SOUTH PARK LOOP PATHWAY CONNECTOR PROJECT

ADDENDUM NO. 1

May 27, 2016

6 RECTANGULAR RAPID FLASHING BEACON DETAIL (RRFB)
2.3 N.T.S.

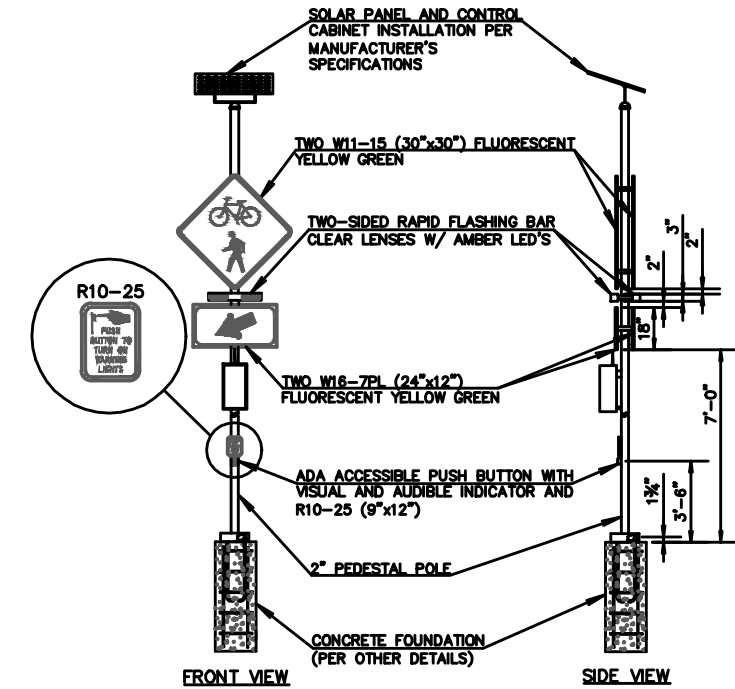
1. The Rest Area Pavers shall be constructed in a basket weave pattern.
2. There are three Rectangular Rapid Flashing Beacon (RRFB) installations required. However, one complete RRFB installation includes a pair (one for each side of the road) of the assemblies shown in detail 6/2.3.
